YARRA CITY COUNCIL
Internal Development Approvals Committee
Agenda

-
- 1.1 452-456 Bridge Road and 1 Fraser Street, Richmond - PLN14/0571 - Development and use of the land for partial demolition and the construction of a six-storey building containing 27 dwellings and 2 retail premises (permit not required for retail use), including a reduction in the car parking requirement and a waiver of the bicycle and loading bay requirements.**
-

1. This report provides Council with an assessment of Planning Application PLN14/0571 at 452-456 Bridge Road and 1 Fraser Street, Richmond and recommends approval, subject to conditions.

Figure 1 – Previous proposal refused by VCAT

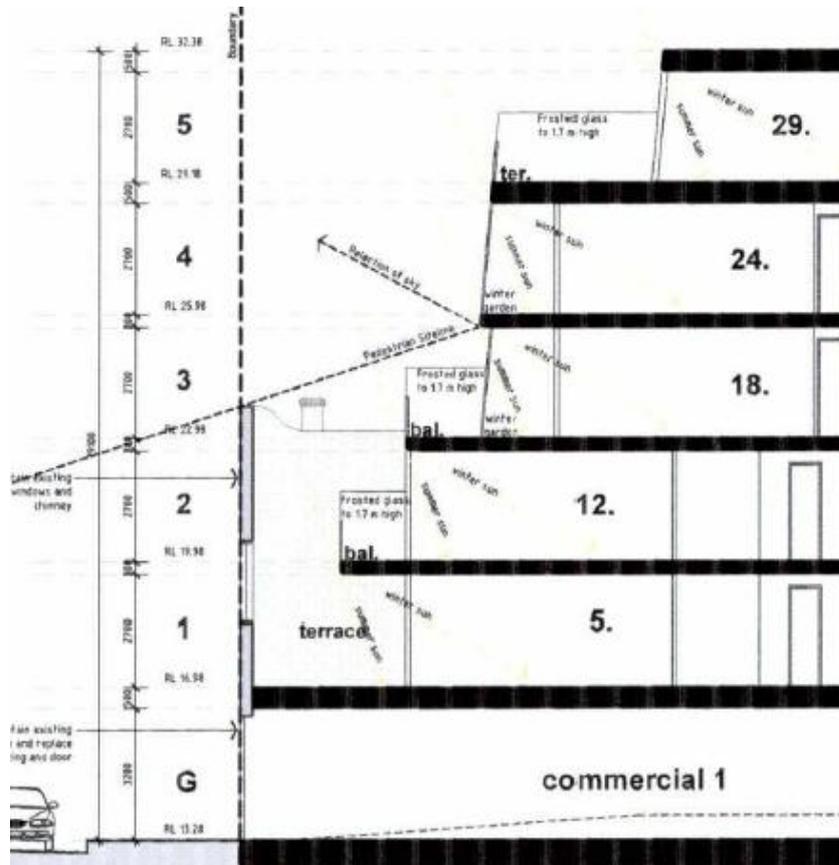
252. The setbacks from the front facade outlined above were considered inadequate, with Ms Riddett stating that the overall height of the building would only be acceptable if there was greater concealment of the new built form. The figure of 9.9m was originally recommended as an appropriate setback for the lower levels, with this length being equivalent to the depth of the existing main roof form on the heritage buildings. It was considered that this distance would be likely to create the appearance of a separate building behind the existing heritage fabric. Ms Riddett later revised this figure to 15m, when it became evident at the hearing that the original sightline diagrams from the northern side of Bridge Road were incorrect, and more of the new building would be visible from this location.

253. The Tribunal agreed that the original setbacks were not acceptable and did not achieve a suitable division from the heritage fabric, with the third and fourth floors only setback marginally further than the two levels below. It was considered that these setbacks did not create sufficient visual separation between the heritage fabric and the new building, thereby allowing the proposal to be dominant in the Bridge Road streetscape. Whilst the Tribunal did not provide any guidance as to what setbacks would be acceptable, it noted that the height, setbacks and materials would all have to be considered in conjunction to result in an acceptable outcome for a future application.

Figure 2 – Current proposal

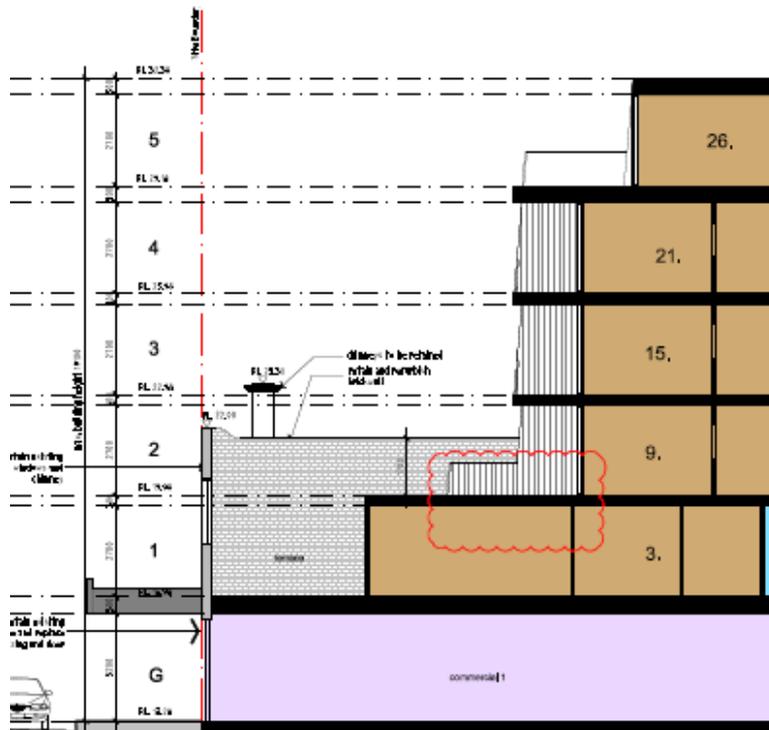
255. In general, setbacks of the balustrades and apartment walls have increased between 3m-4.5m, with the upper levels provided with greater setbacks than those below. Whilst these setbacks do not accord with the 15m setback recommended by Ms Riddett, it is considered that they achieve the intent of the heritage advice, which called for the setbacks to be equivalent to the depth of the existing main roof form and for the new building to be clearly distinguishable from the existing heritage place. The 9m setback of the upper level balconies and the minimum 10.7m setback of the new façades, whilst still allowing visibility from Bridge Road, will create the impression that the building is clearly a separate element within the heritage streetscape.
